2025 REVISION TABLE

(To the 2024 Electric Line Extension and Service Standards)

PAVEMENT REPLACEMENT AND BACKFILL DETAIL

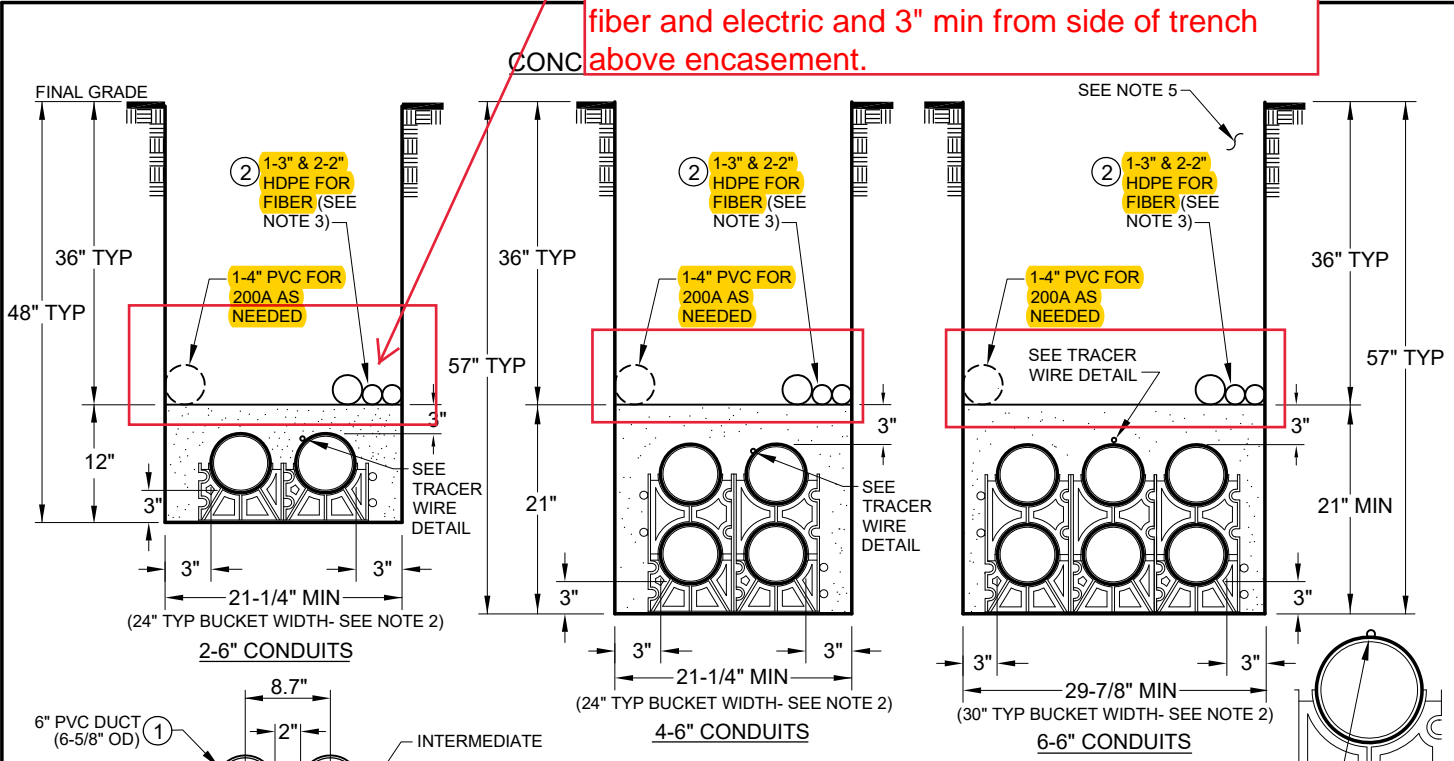
Deleted notes 1 & 2 and moved note 6 to note 1 position.

CONCRETE ENCASED DUCT BANKS

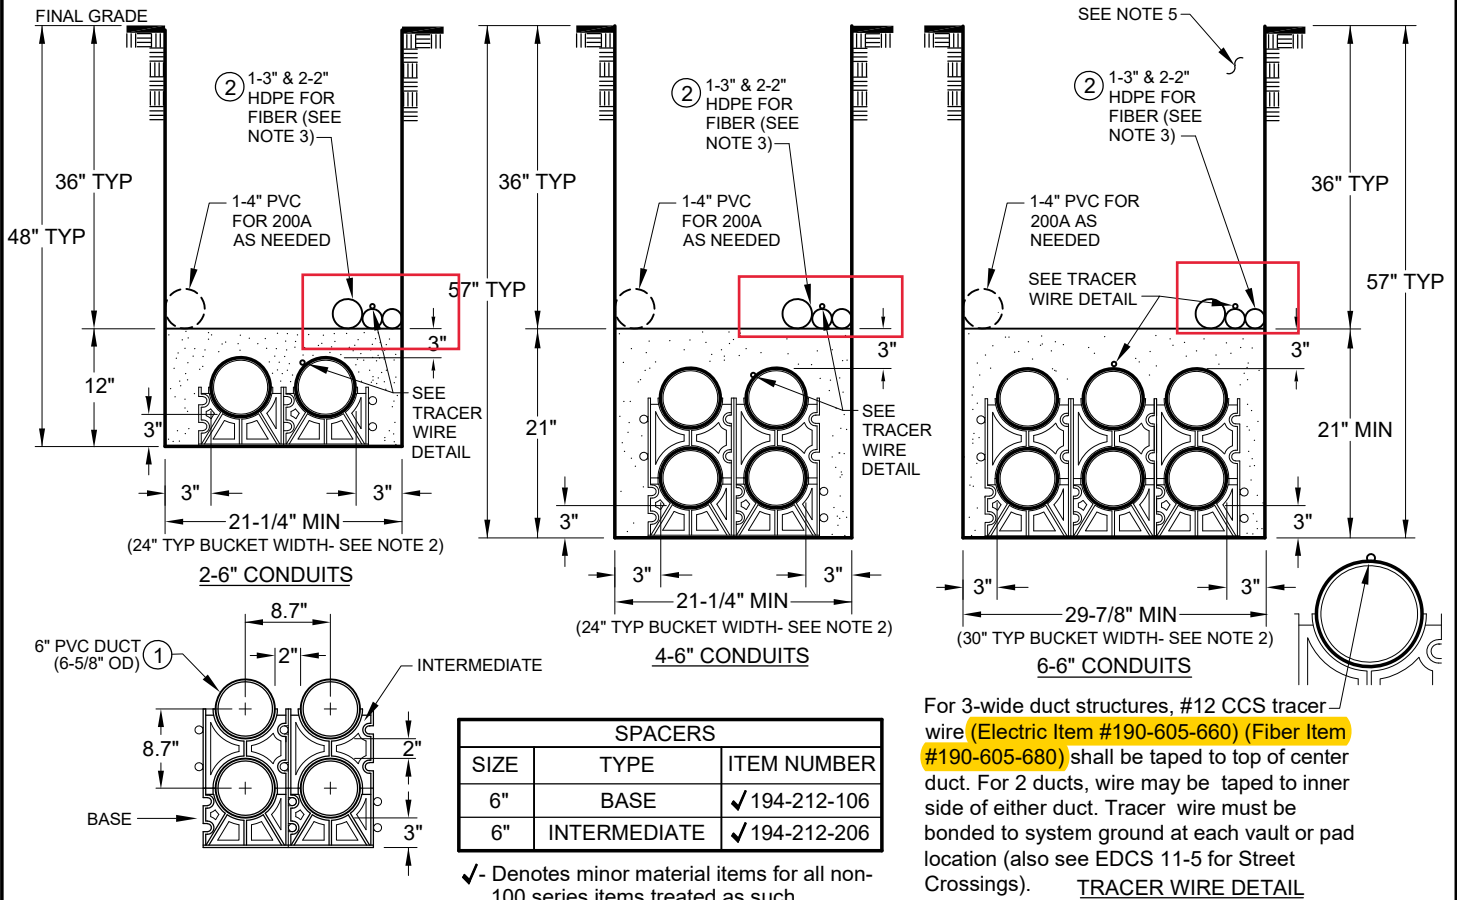
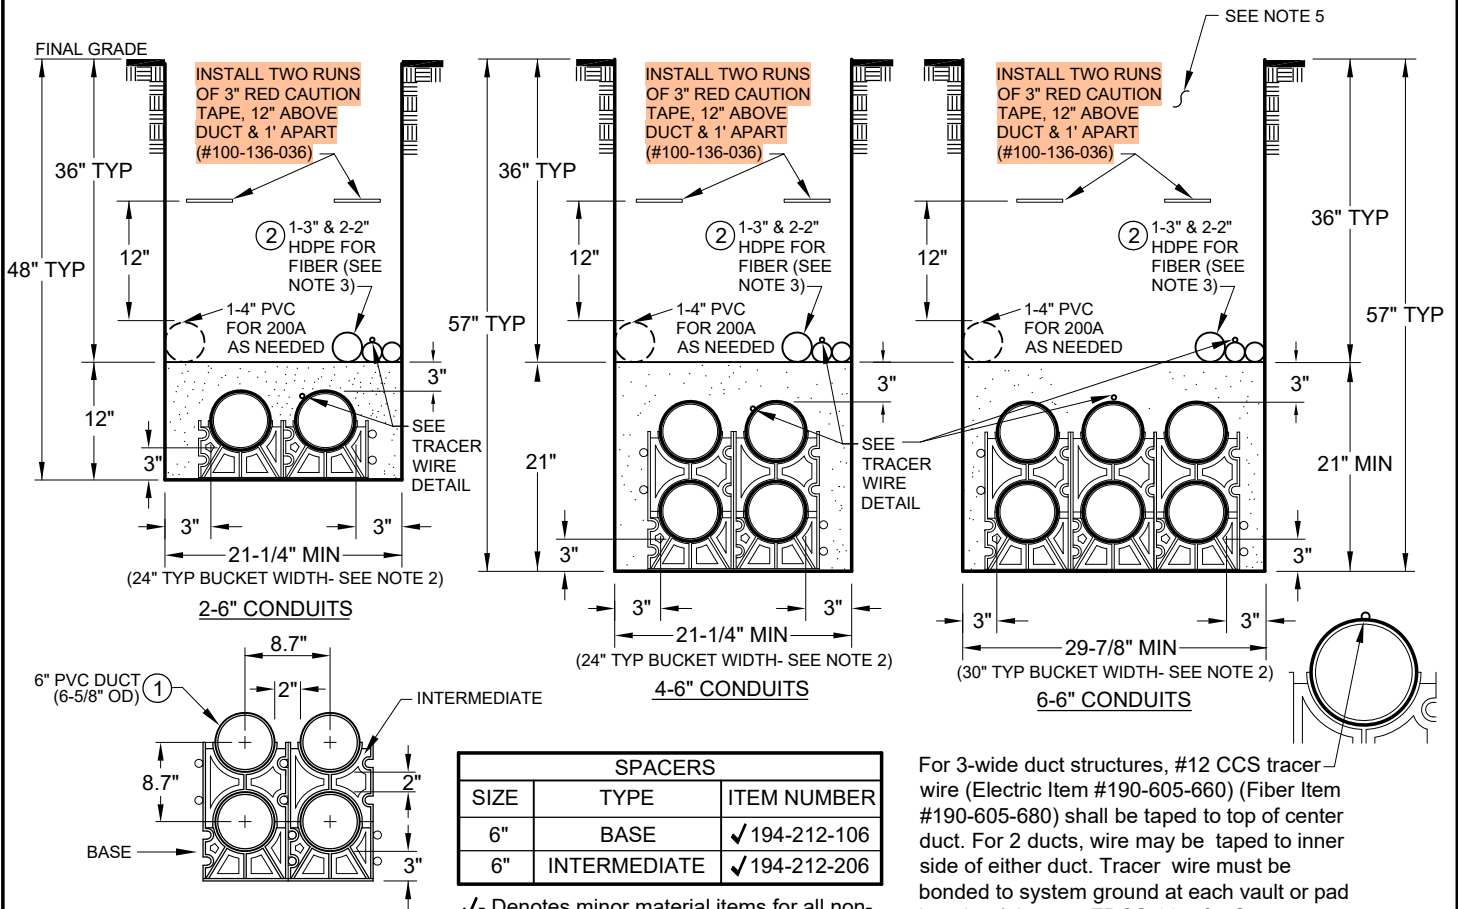
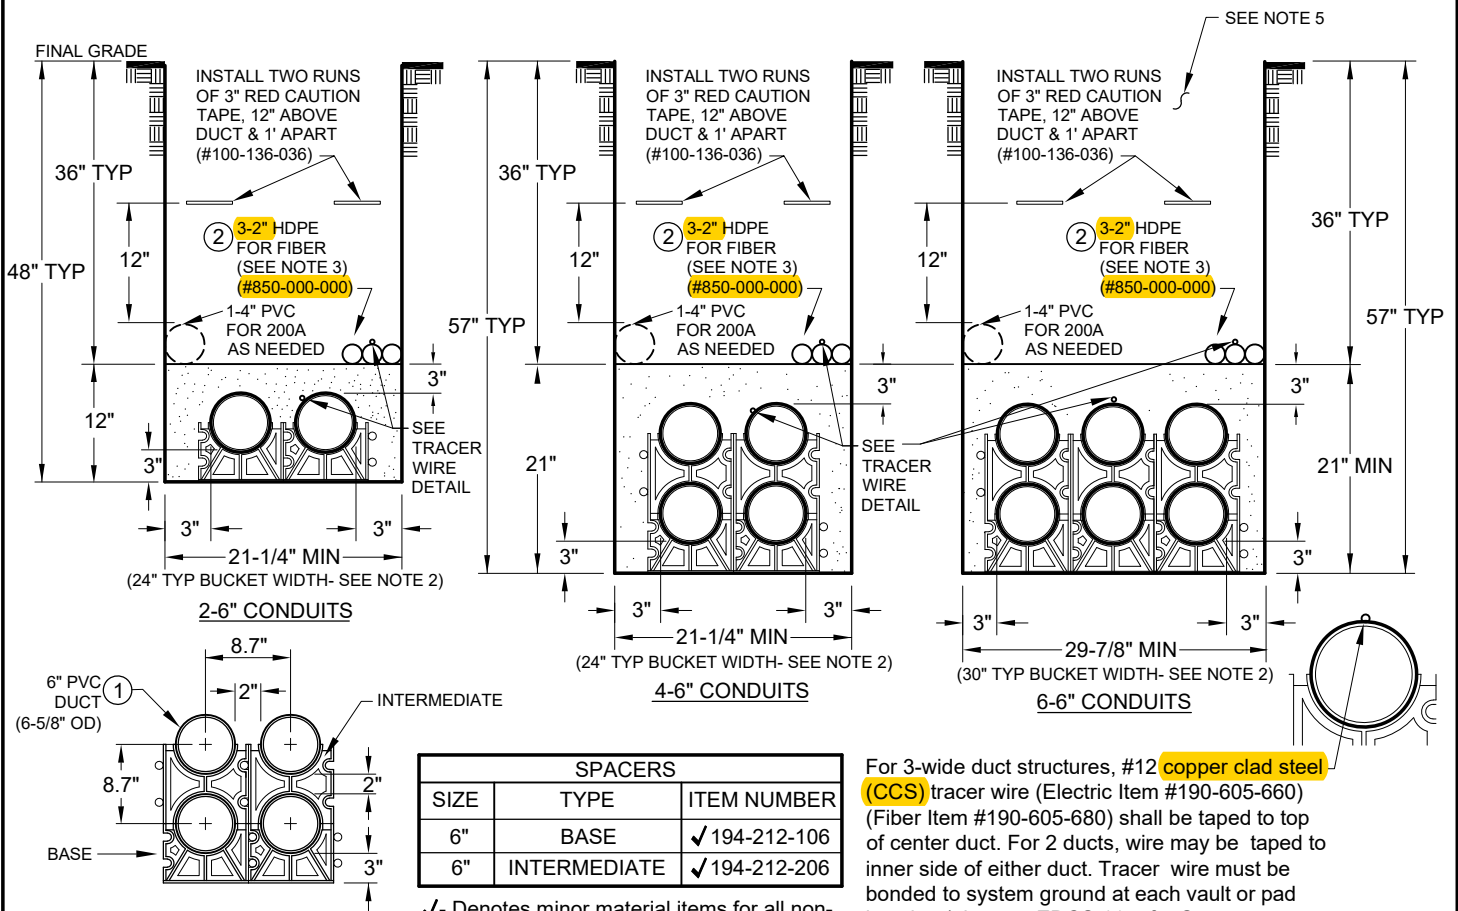
Updated notes and drawings for Fiber conduit and tracer wire. Added note about trench marking tape.	Appendix F, 11-2	Concrete Encased Duct Banks	-Updated notes and drawings for Fiber conduit and tracer wire. -Added trench marking tape note to drawing: <u>“INSTALL TWO RUNS OF 3" RED CAUTION TAPE, 12" ABOVE DUCT & 1' APART (#100-136-036)”</u>

Removed old note 8 about 12" separation between fiber and electric and 3" min from side of trench above encasement.

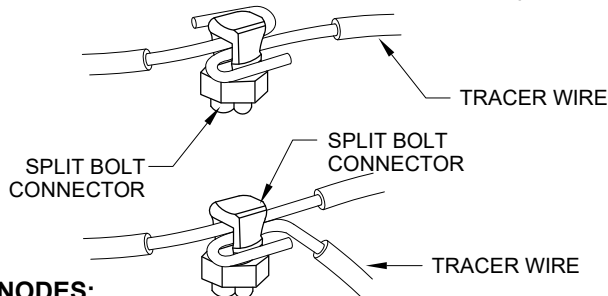
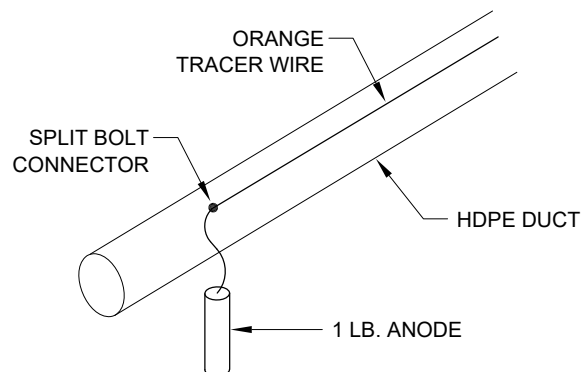
Added new section for Fiber Conduit.	Appendix F, 11-5	Tracer Wire for Empty Ducts	Added new section for Fiber Conduit.
Revised exception note about 3' clearance to Fiber, added note about horizontal clearance to fiber boxes, & updated note 2 for Joint trench with Utilities' Fiber.	Appendix F, 18-304	Clearances Of Ug Electric Conduit/Cable from Other Facilities	<p>Reformatted wording for Exception "e" that reduces clearance Telecom/ fiber to 3' when the requirements listed are met, emphasized the past requirement that high pressure gas main requires a 10-foot horizontal clearance with no exceptions, and added text "<u>The horizontal clearance distance applies to fiber appurtenances, to include boxes (boxes must be the required horizontal and vertical distance away from gas and electric and shall not be placed over electric or gas pipe).</u>"</p> <p>Updated note 2: "These clearance matrix table dimensions are for separate trenches. <u>Joint trench between Gas and Colorado Springs Utilities Telecom./ Fiber requires a 1' radial separation. Joint trench between Electric and Colorado Springs Utilities Telecom./ Fiber requires a 3" in concrete and 6" in fill earth radial separation.</u>"</p>
